Service Bulletin #SB008

Subject: Headramp Attaching Hardware Update

**Models Affected: Certain Headramps Manufactured
between July 13, 2007 and March 31, 2009**

ORIG. BY:	PROG. NO.	MATERIAL	MATERIAL DESCRIPTION	SIMILAR TO	SCALE
BH	X	X			1:1
ORIG. DATE:	PROG. BY	MAKE FROM	PART YIELD	DWG. NO.	SIZE
3/1/2010				XX	A
CHK BY:	PROG. DATE	FINISH	WEIGHT	PART NO.	REV
				120873/120874	IR
CHK DATE:	TITLE				
	Tamper Resistant Post Con.

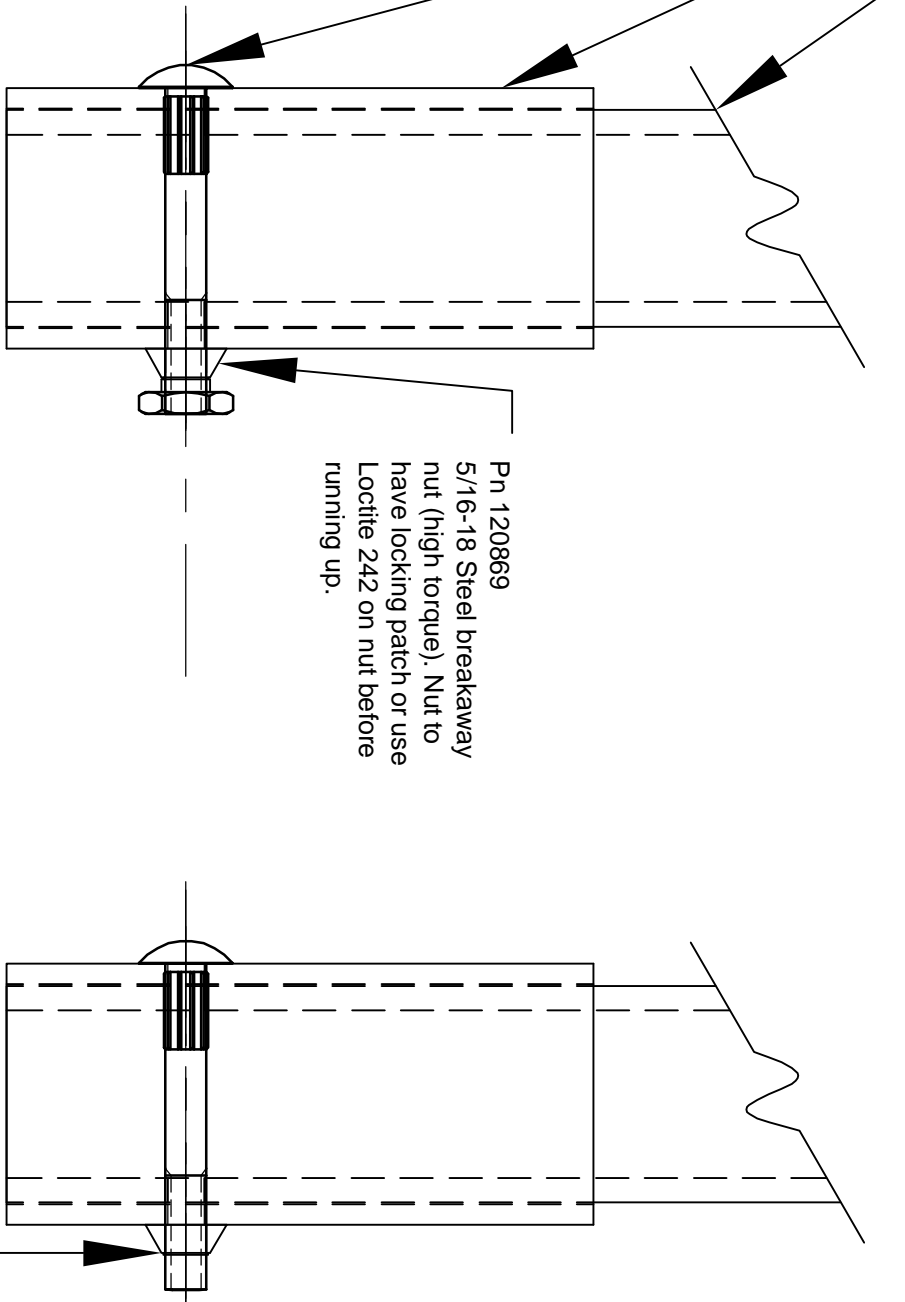
Pn 120868
5/16-18 x 2 1/2" round
head rib neck bolt.
Drill existing hole in
outer tube both walls
to 1/4" (.344") diameter and
drive bolt into place.

Pn 120869
5/16-18 Steel breakaway
nut (high torque). Nut to
have locking patch or use
Locite 242 on nut before
running up.

Torque nut until hex breaks
away. Verify that nut is
fully seated.

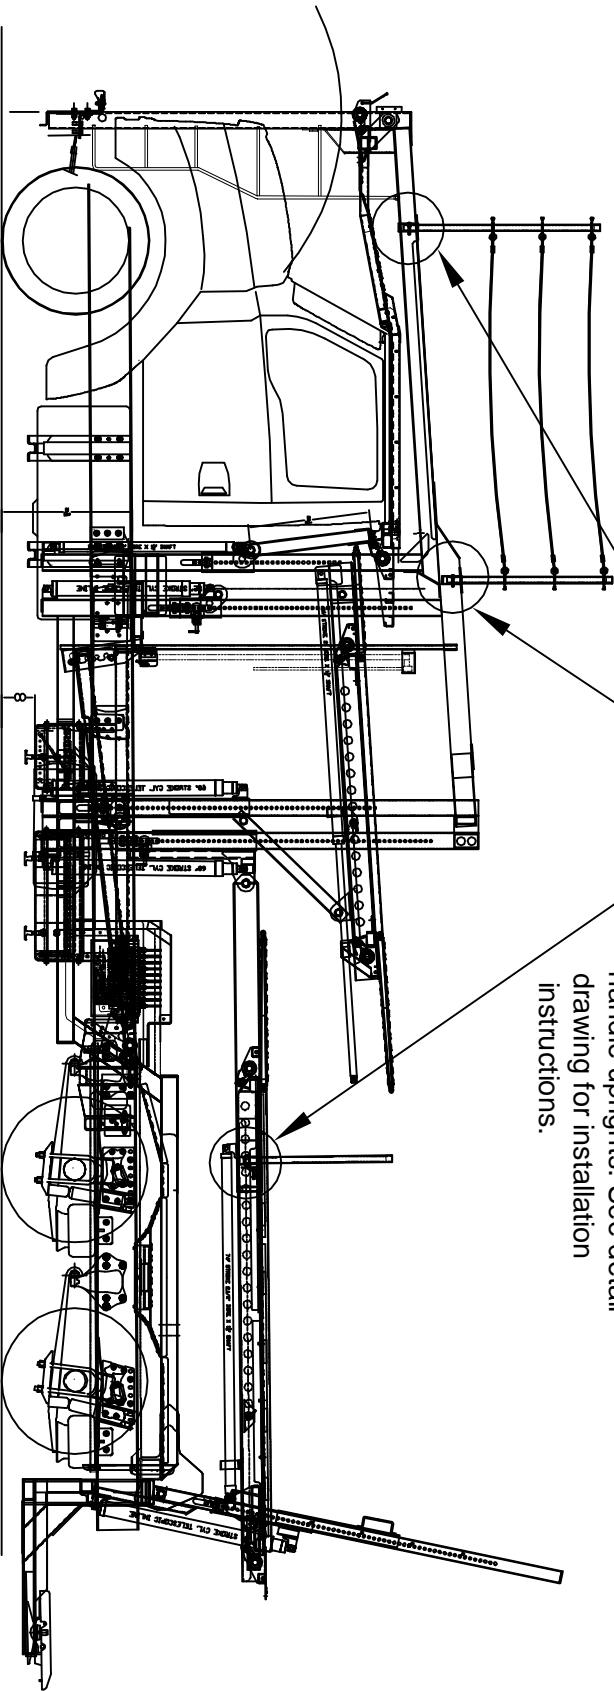
Typical cable handrail/ grab handle installations requiring updated connection hardware. Install on all cable handrail or handle uprights. See detail drawing for installation instructions.
